NRC DOCKETS 50-321, 50-366
OPERATING LICENSES DPR-57, NPF-5
EDWIN I. HATCH NUCLEAR PLANT UNITS 1, 2
NUREG-0737 ITEM II.K.3.28 - VERIFY QUALIFICATION OF
ACCUMULATORS ON AUTOMATIC DEPRESSURIZATION SYSTEM VALVES

ADDITIONAL INFORMATION REGARDING NUREG 0737 ITEM II.K.3.28 QUALIFICATION OF ACCUMULATORS ON AUTOMATIC DEPRESSURIZATION SYSTEM VALVES

FIGURE 1
ADS VALVE ACCUMULATOR SYSTEM
(TYPICAL)

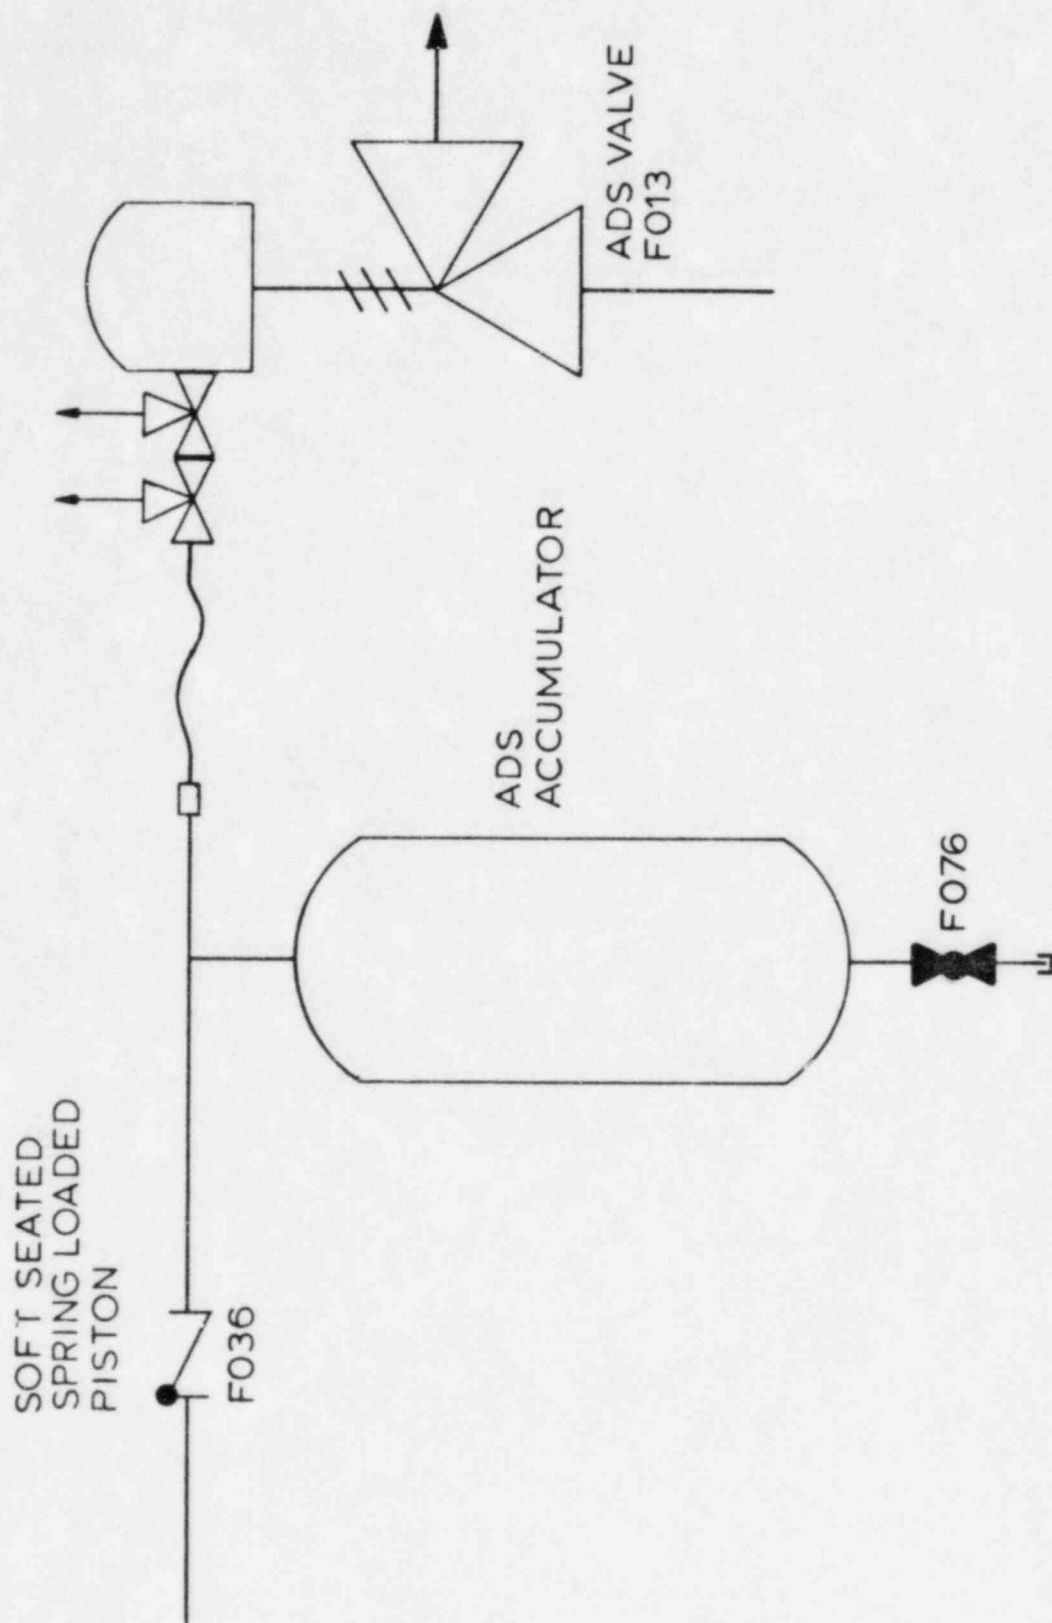
Define the periodic leak testing of the ADS accumulator system (i.e., the time interval between these leak tests, along with a concise description of the test procedure employed).

Leak tests will be performed on all ADS accumulator systems at least once per operating cycle following adoption of the Technical Specifications described in the response to Item 11. The leak test first requires venting of the pneumatic supply header upstream of check valve F036 (Refer to Figure 1). A test pneumatic supply is then applied at the accumulator drain valve (F076). The makeup flow required to maintain the accumulator system pressure is measured in order to determine the total assembly leakage rate. Since the accumulator drain valve is normally closed and capped, leakage through the valve seat and cap will not be tested.
